High Street Upgrade Project

Response to Submissions Document

EPA ASSESSMENT NO: 2181

February 2019

Figure 1 Corrected met data set (left) compared with erroneous met data (right)

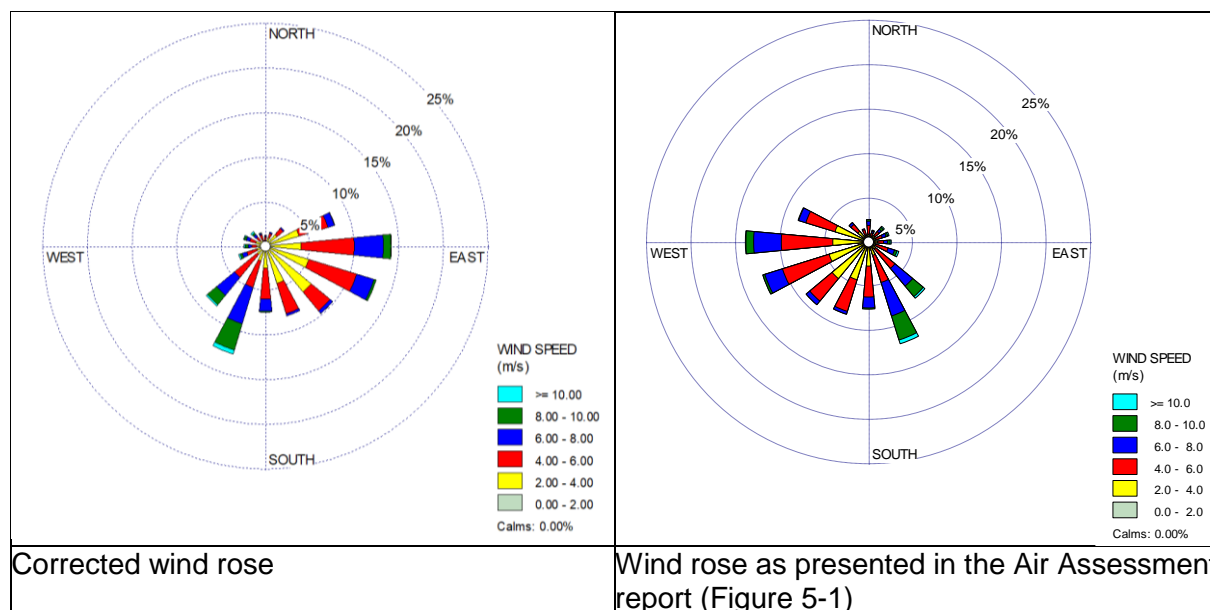
- The meteorology data file used in the modelling is not from Swanbourne, as reported in the Air Assessment report. Please confirm the site of the meteorological dataset used.
- Meteorological data from Swanbourne (approximately 700m from the coast) or other near coastal stations is not representative of the site as the proposed upgrade is located significantly further inland (approximately 2km).
- The percentage of the calm conditions and light winds are much less at Swanbourne site compared with Wattleup and South Lake sites air quality monitoring stations.

This review resulted in detection of an error in the development of the meteorological data file used for the assessment during the manipulation of 1-minute Bureau of Meteorology observations into a 1-hour average for use in the dispersion model.

A wind rose for the corrected met data set is shown below (left) compared with the erroneous meteorological (met) data set (right). The corrected wind rose is in agreement with the wind rose provided by DWER Air Quality Branch in subsequent correspondence via email.
